County of Santa Clara
Airport Land Use Commission

DATE: December 16, 2020, Regular Meeting

AGENDA

County of Santa Clara
Department of Planning and Development

Figure 2
Existing General Plan Land Use Designations

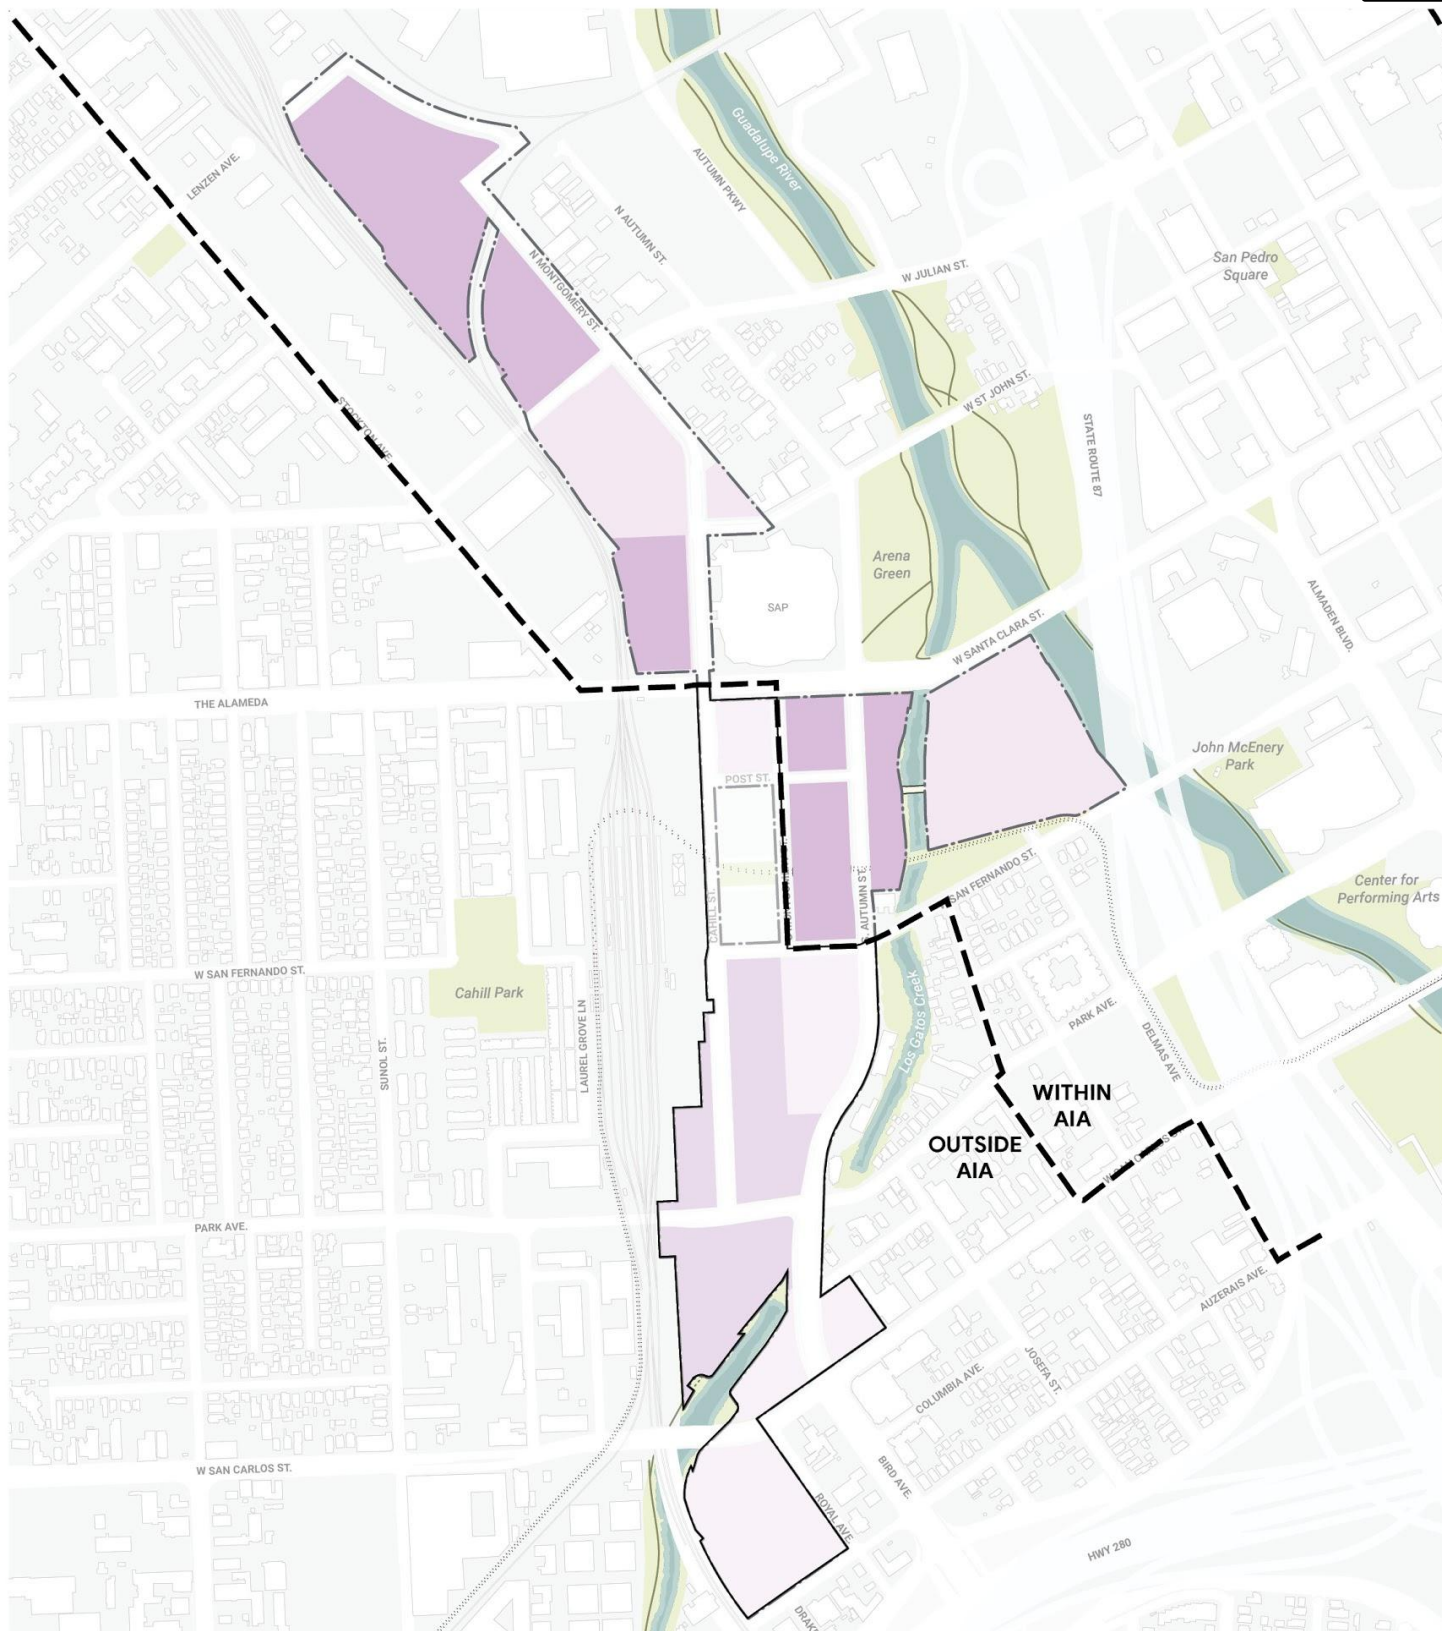
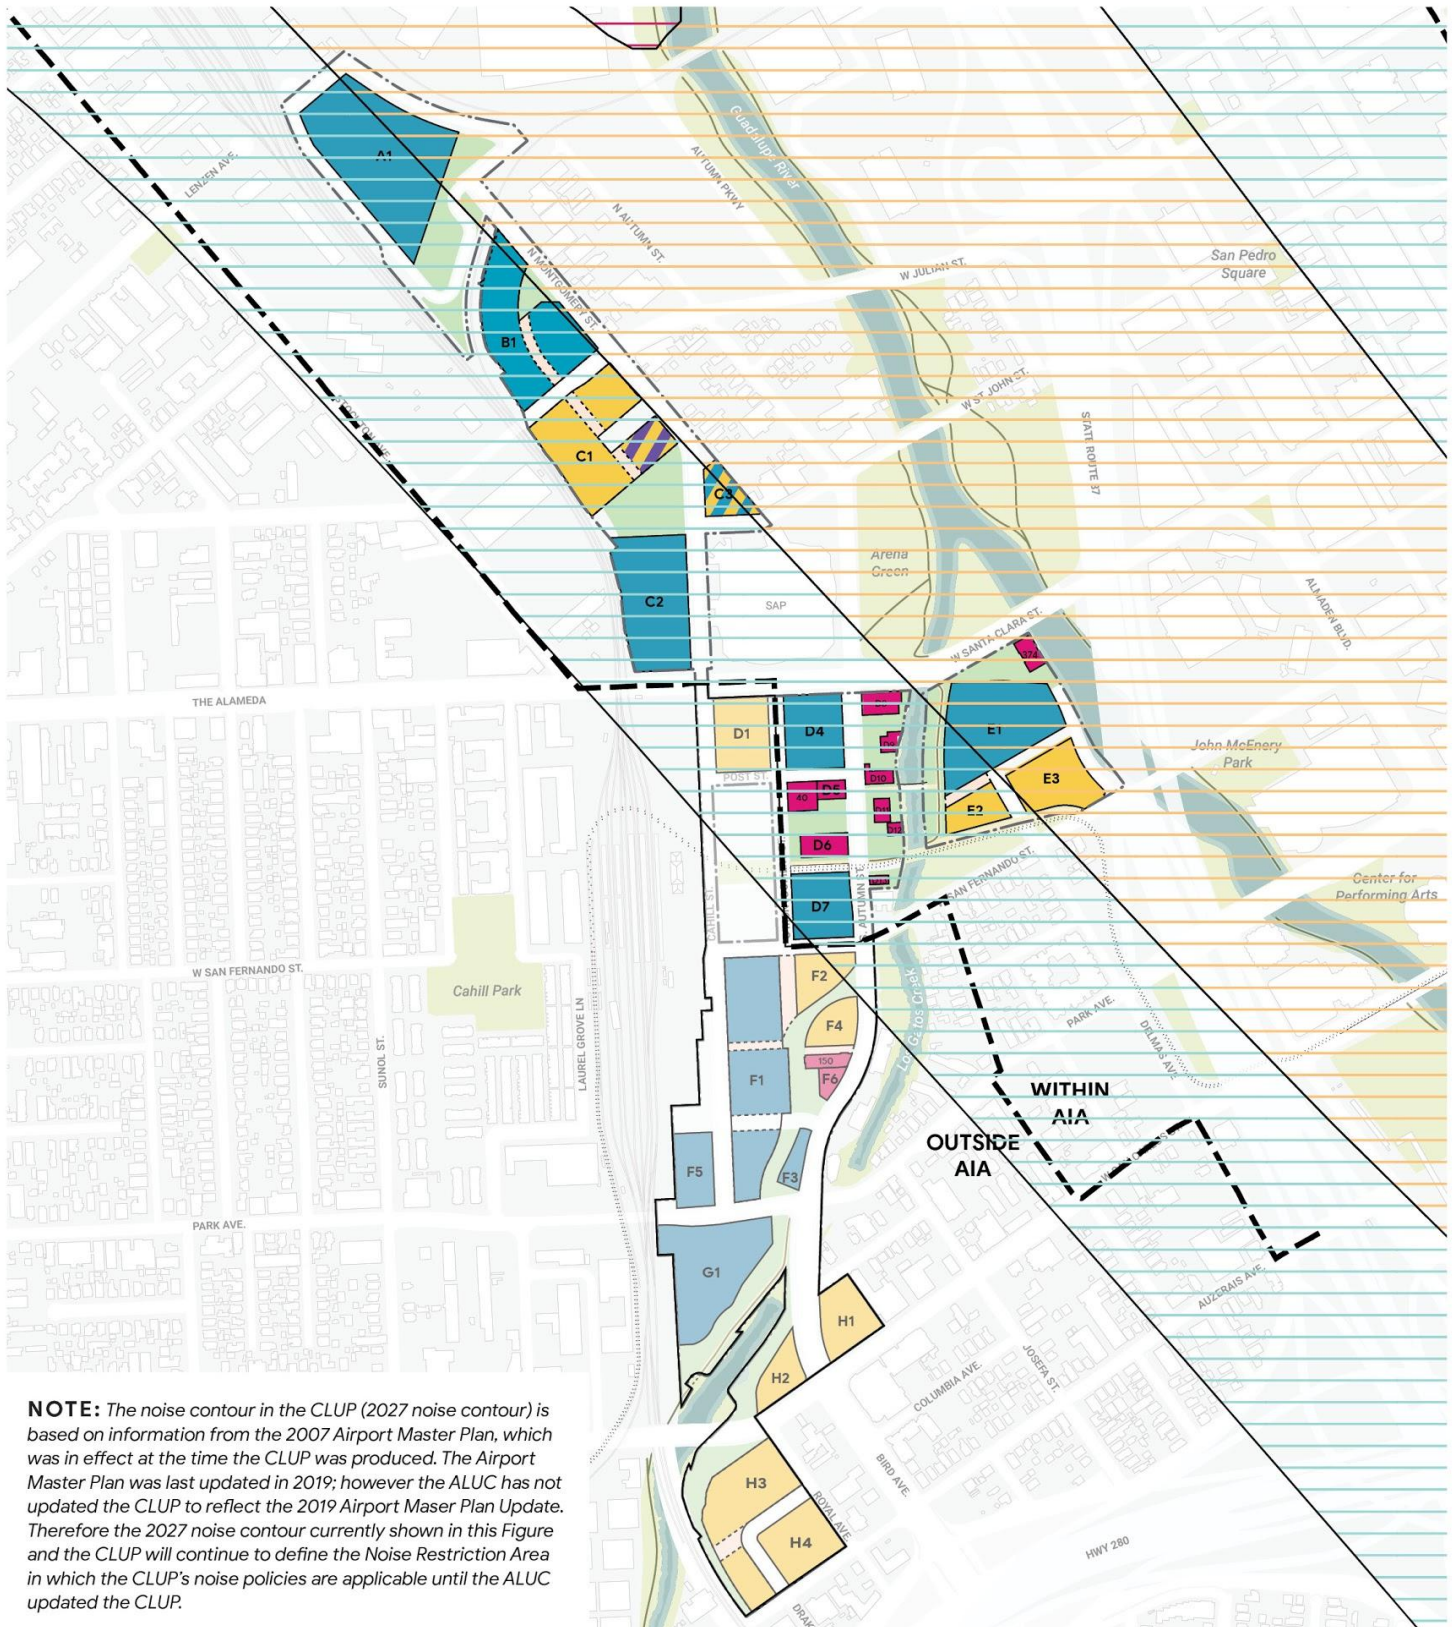
As can be seen on Figures 2 and 3 of the referral, the General Plan Amendment of the project entails amending the existing General Plan designations of Transit Employment Center, Public / Quasi Public, Downtown, Commercial Downtown and Open Space to Downtown and Commercial Downtown, to allow for the mixed commercial, office, retail and residential development proposed in the plan.

Figure 4
Noise Contours 2027 Forecast (dBA CNEL)

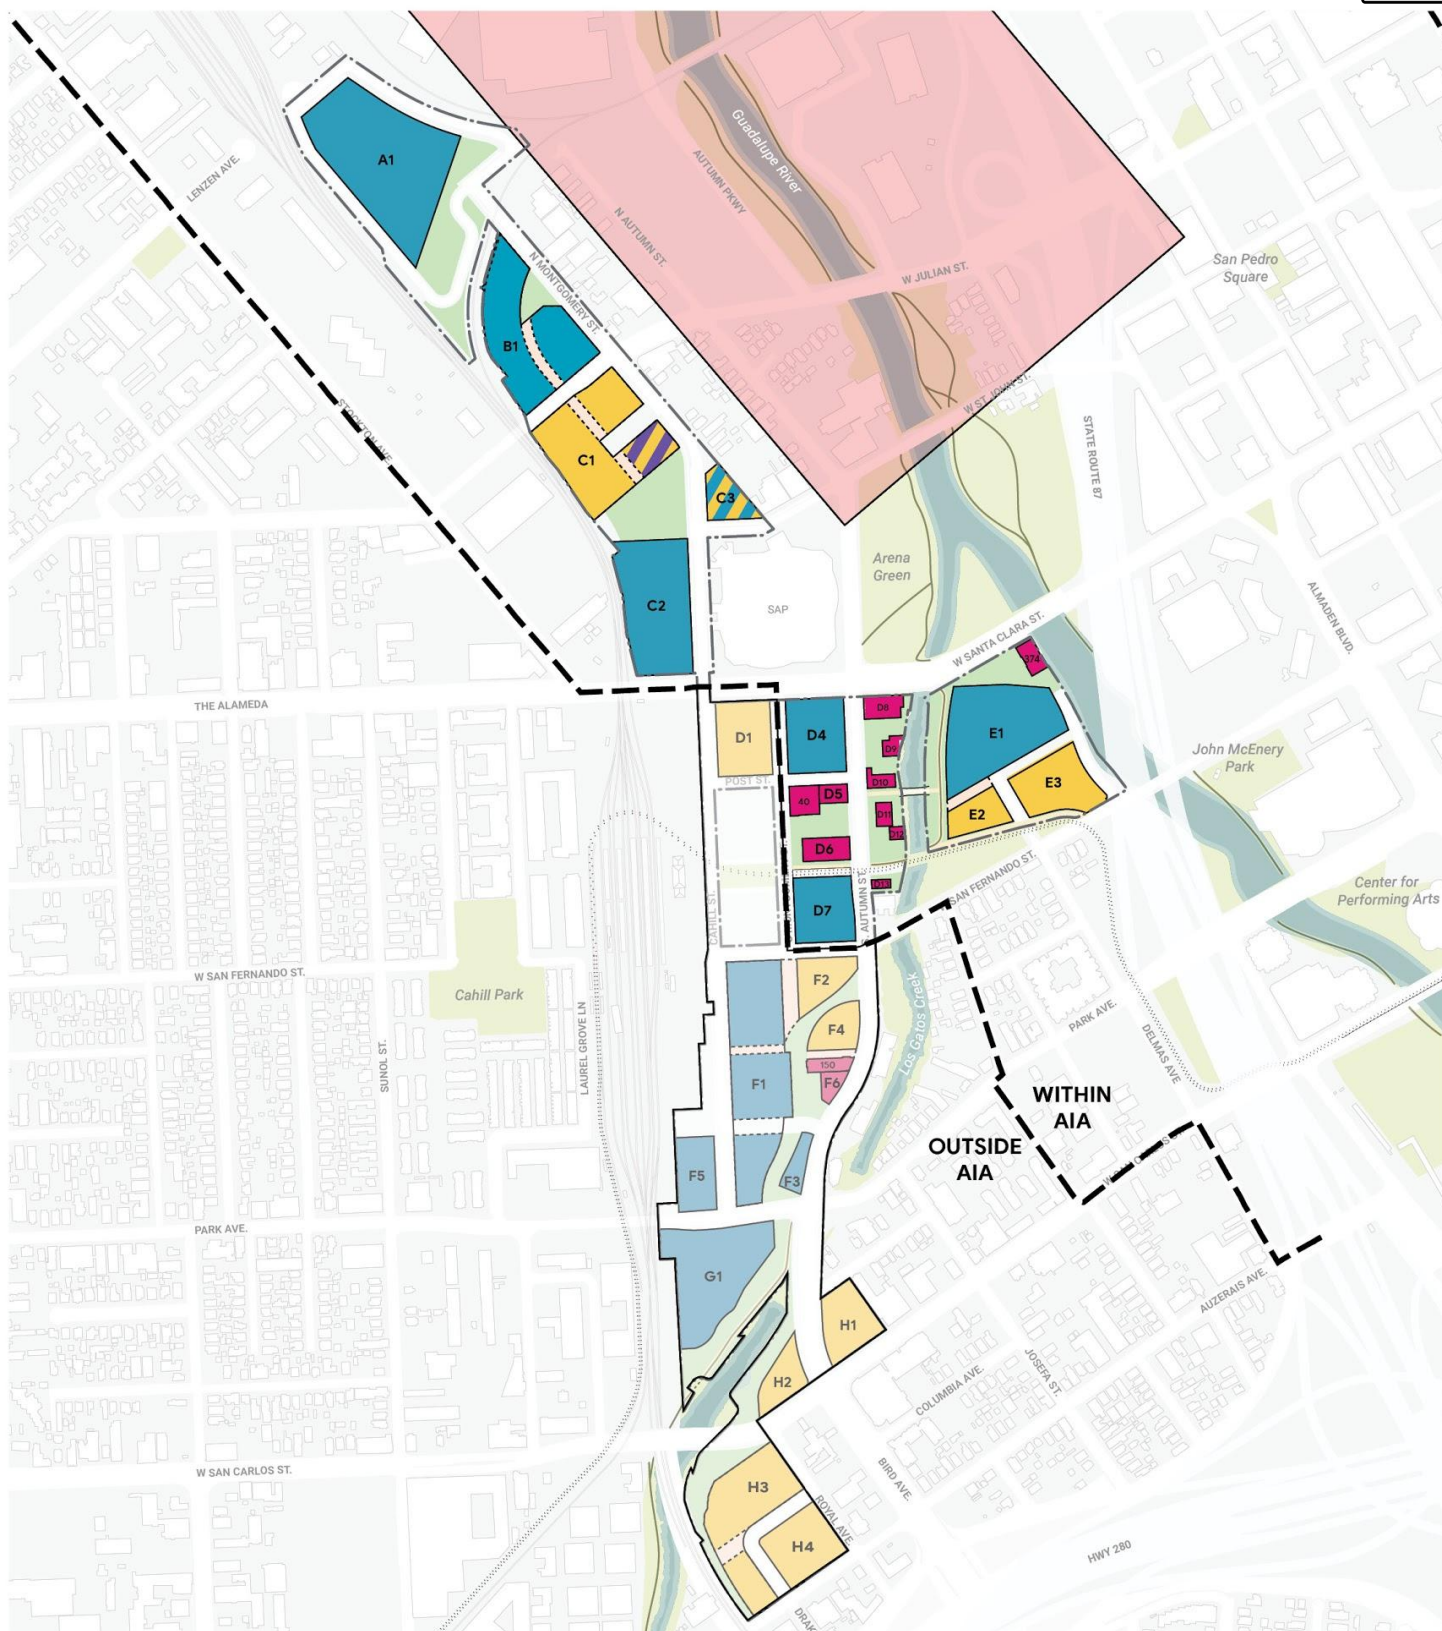
As can be seen on Figure 4 “Noise Contours 2027 forecast”, the project area is between the 60 and 65 dBA CNEL noise contours. The General Plan Amendment would allow Employment Commercial, residential and retail uses within both CNEL noise contours.

Figure 6
Existing Heights: West OEI Corridor Heights

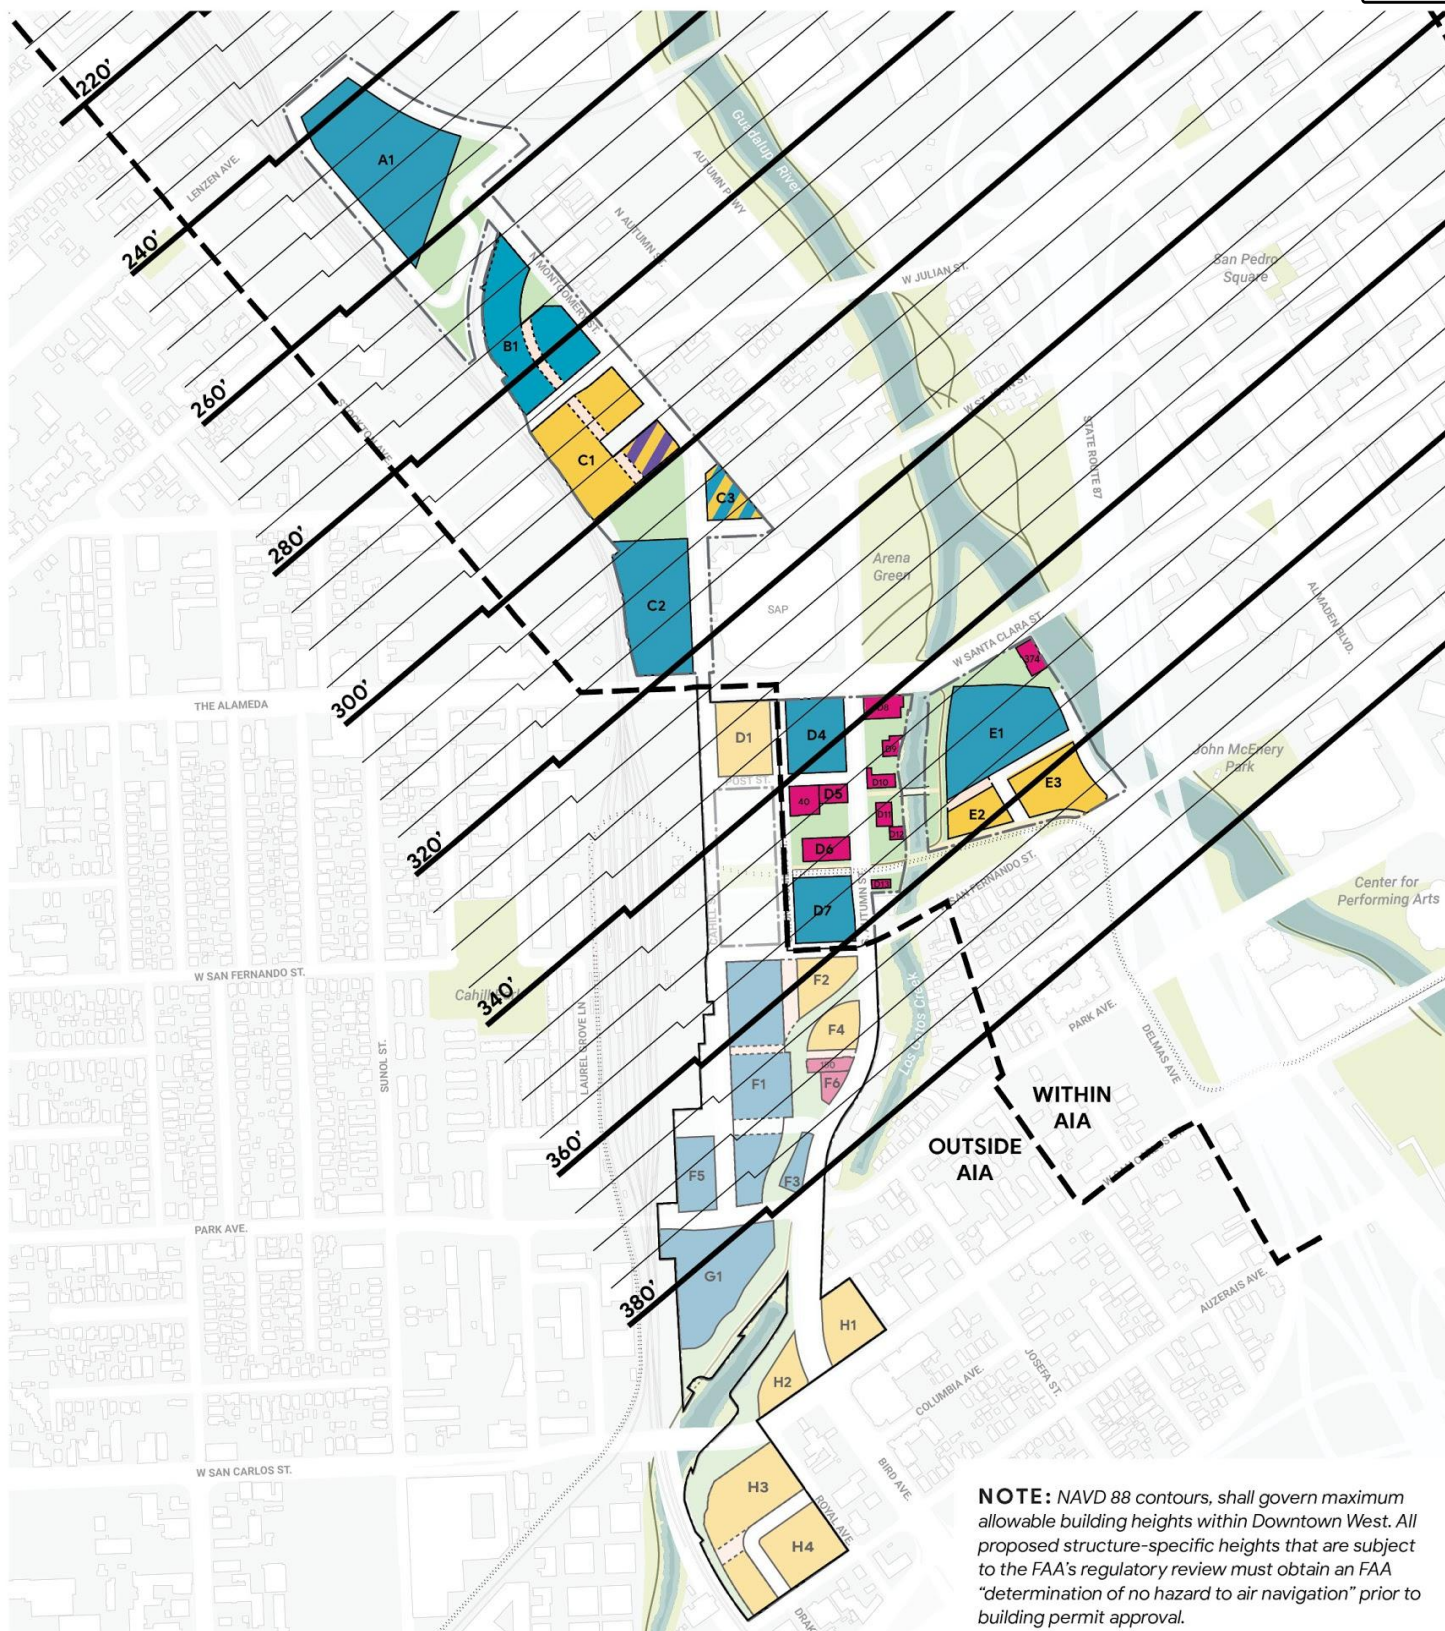
Figure 6 of the referral shows “existing heights / OEI”, but is actually the FAA FAR Part 77 surfaces. Figure 7 shows the Terminal Instrument Procedures (TERPS) surfaces. And Figure 7 shows the ground elevations. In June of 2020, the San Jose City Council adopted TERPS as the height limitation surfaces for the area south of SJC.
